**KARANG AMPEL - CIREBON
ROAD SAFETY AUDIT REPORT
As Constructed**

Strategic Roads Infrastructure Project (SRIP)

PACKAGE KARANG AMPEL - CIREBON ROAD SAFETY AUDIT REPORT Existing Road Stage - As Constructed June 2010

The Traffic Signal Junction Has Not been Improved as Described in Drawings

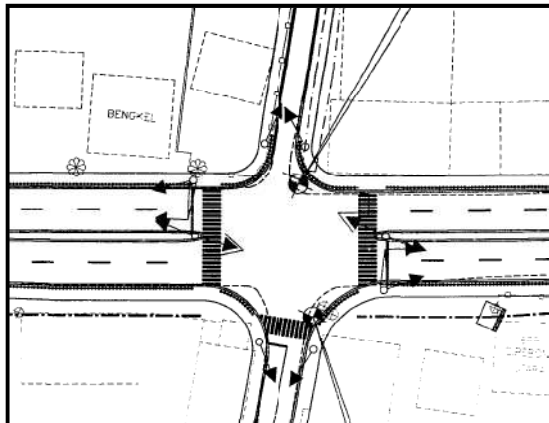
The proposed design included new signal equipment, islands, footways, pedestrian barriers, but this was not implemented. The junction is still very unsafe for pedestrians and much of the signal equipment is not working or damaged, see photos below:

Shoulders & Pedestrian Paths are Used for Parking by Becak & Public Transport

Junction is Un-Safe for Pedestrians & All Road Users

Poor Condition of Traffic Signals (Damaged and Broken) and Pedestrian Crossing Blocked by the Poles

- Add rumble bars to all approaches
- Ensure all broken signal equipment repaired promptly
- Upgrade main signal head on each approach to large high visibility specification

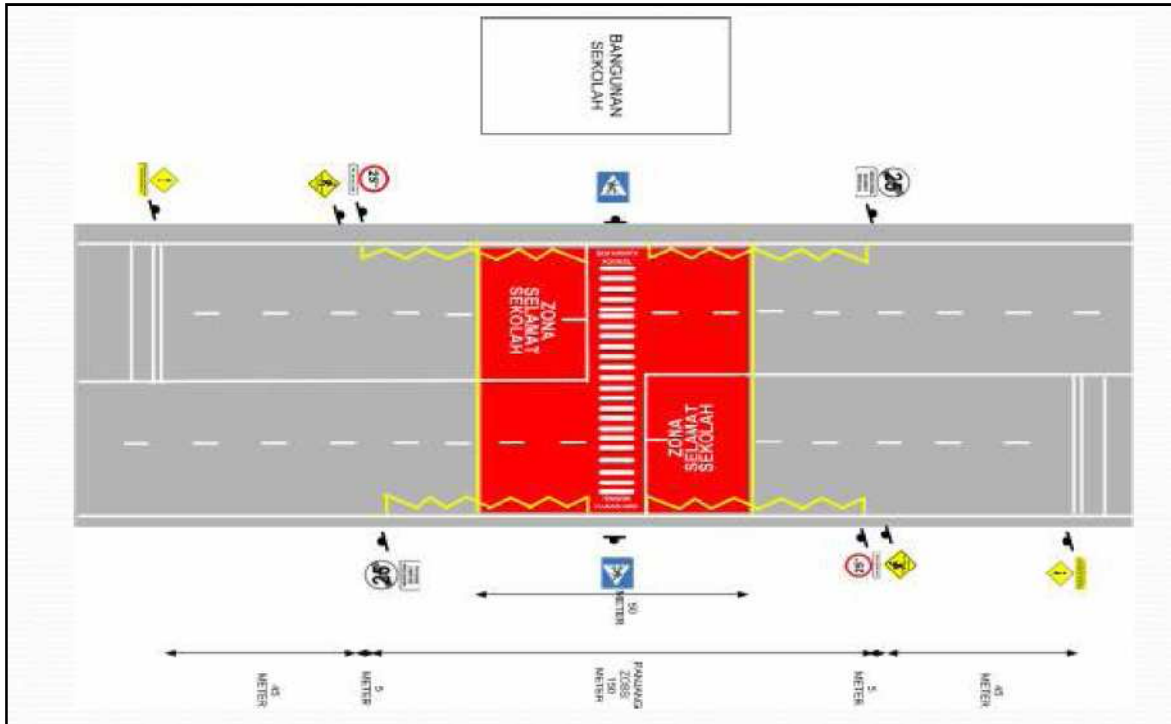
No school zones have been installed - unlike all other projects - although there are several locations where hundreds of pupils have to cross the dual carriageway, see photos below.

- Urgent consideration needs to be given to adding standard school zone markings, speed limits rumble bars etc. at all schools, see standard details below:

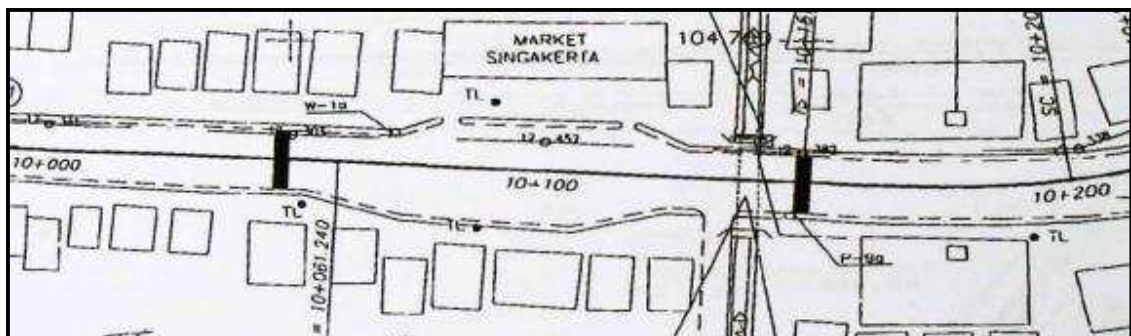
Most of Activities on, or near, the Kerbside such as car parking, local accesses, commercial activities etc. can have adverse affects on the freedom of movement to pedestrians and motorised road users alike and can jeopardize their safety.

Many Vehicles are parked at the shoulder on the project, causing sudden braking or nose-to-tail shunts and also blocking visibility for any road user;

Similar problems are caused by buses picking up or dropping their passengers

Little or no effort has been made to design parking or waiting areas or bus stops. In consequence the road is blocked congested and dangerous at busy locations.

- **Review need for bus stops, parking and loading areas and design and install appropriate facilities**
